Revision of Site Plan

ROSP-3580-03

DDS-640

TECHNICAL STAFF REPORT

SITE PLAN

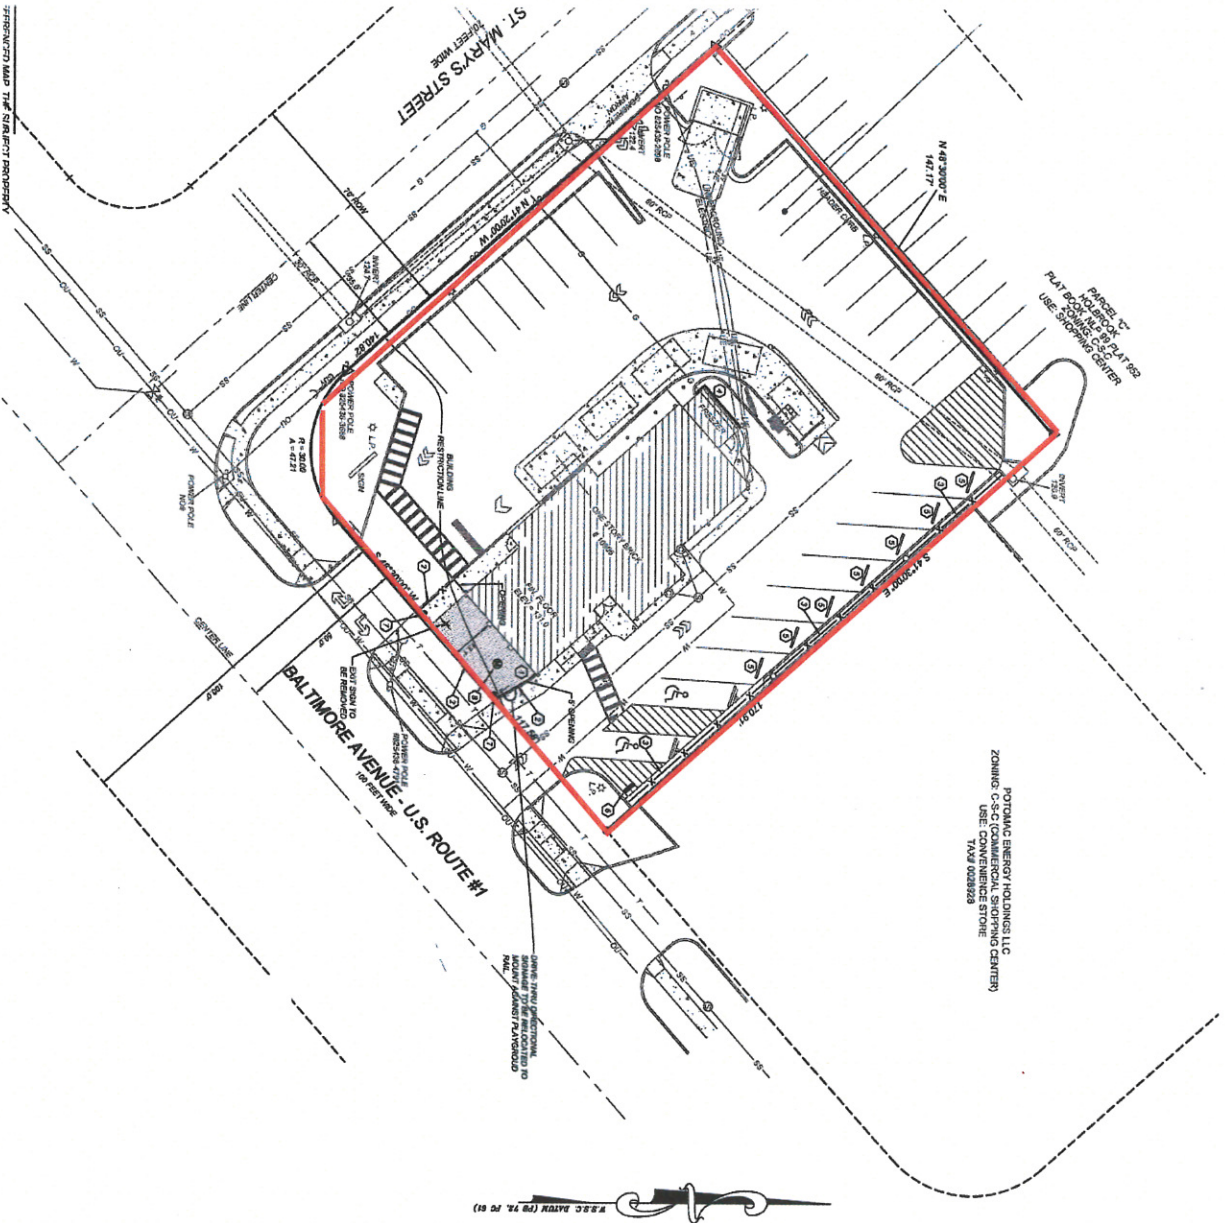
3. The ICS exterior freezer box is identified under the Site/Utility Keynotes on the Special Exception Site Plan (Patio Addition) as Item 4, but is not identified on the actual site plan. Identify the location to which Item 4 refers.

4. I only count 27 spaces, 2 of which are handicapped. The plan states that there are 31 spaces on site, confirm or revise.
5. There are no dimensions provided for the proposed patio extension. Add the dimensions and setbacks from the property line of the patio addition.

6. Show the ultimate right-of-way and centerline, and demonstrate their effect on the property.
7. Is the whole landscape strip being used for patio space? It is hard to tell without any dimensions on the plan. The proposed tables and chairs seem to be in the same location as the original landscape strip. Clarify the drawing to show how much of the landscaping area is being removed to accommodate these new tables and dimensions. If the entire landscape strip is being removed it needs to be clear on the plan, and if only a fraction is being removed that also must be clear.

- c. Clarify the GFA of the existing building.
- d. Add a general note that outlines the proposed work/purpose of the revision.
- e. Label the height of the proposed fence on Sheet C-2 of the submitted plans.

1. Prior to certification of the site plan, the site plan should be revised to provide the following:
 - a. Include brick piers with wrought iron fencing to mirror the design located on the southwest side off Baltimore Avenue.
 - b. Show planters in the patio area. The applicant should save existing or provide new plant materials in planters in the patio area.
 - c. The patio should be constructed using pervious concrete or a similar material.
2.
 - a. Add the plat reference (WWW 72-61) to the site information.
 - b. Add the building restriction line (BRL) as depicted on the plat.

LANDSCAPE PLAN

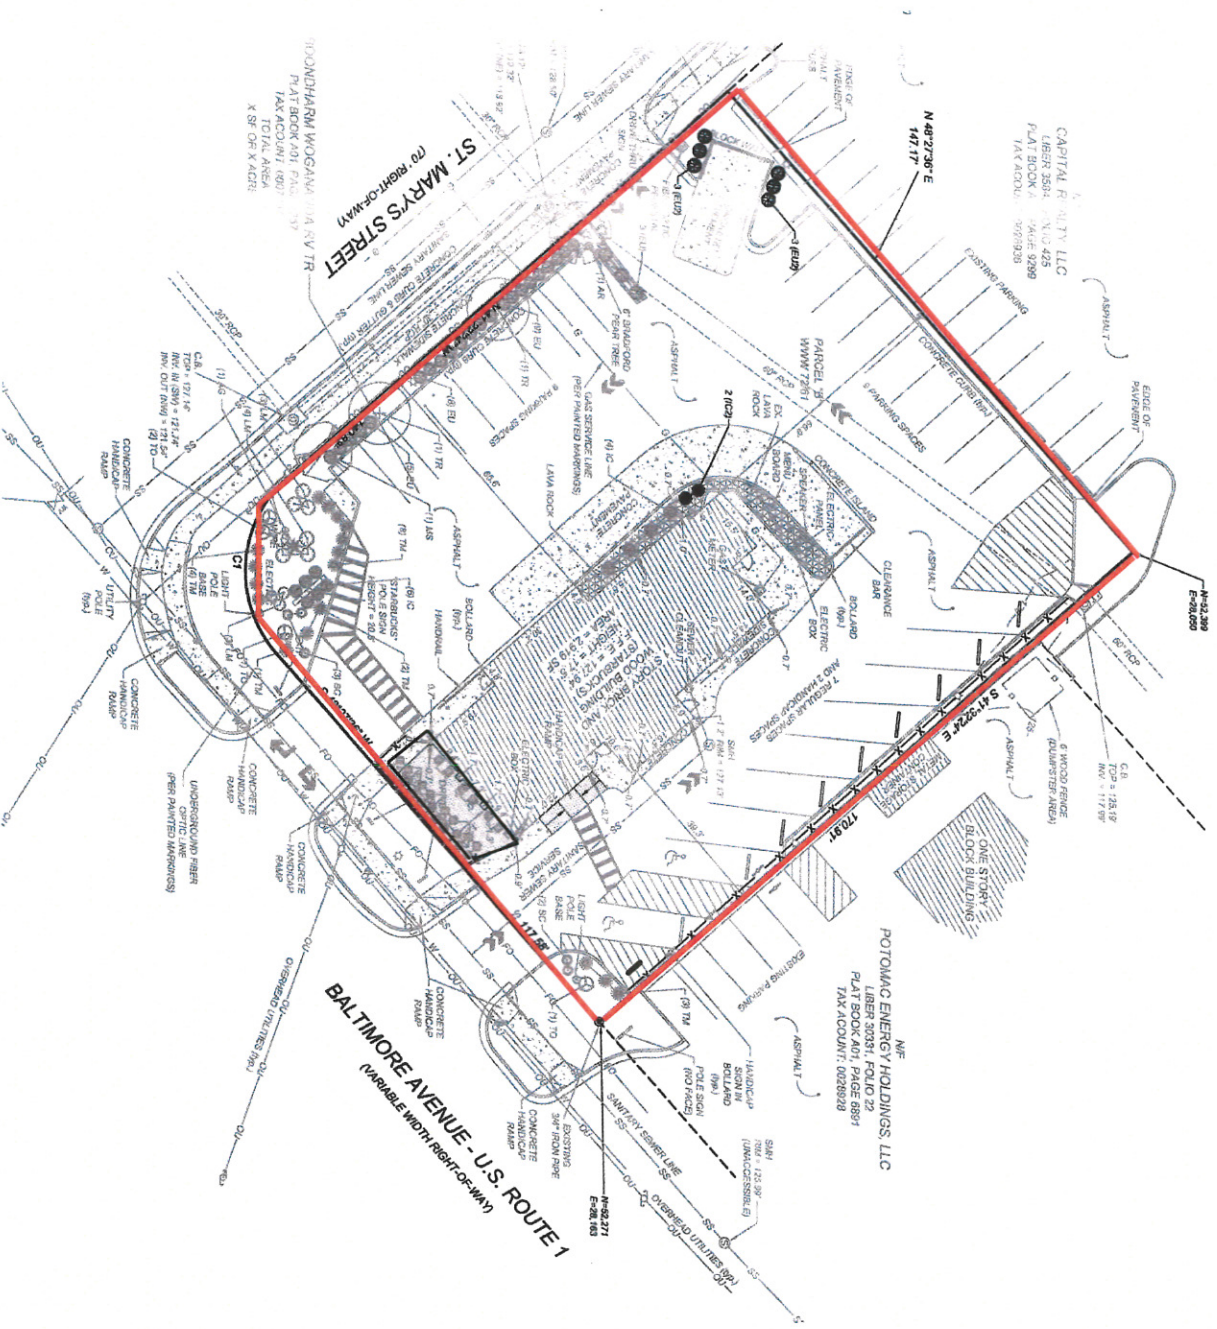
Therefore, staff is recommending approval of the departure request with recommendations to include brick piers with wrought-iron fencing to mirror the design located on the southwest side off Baltimore Avenue. The applicant should also save or provide existing plant materials in planters in the patio area.
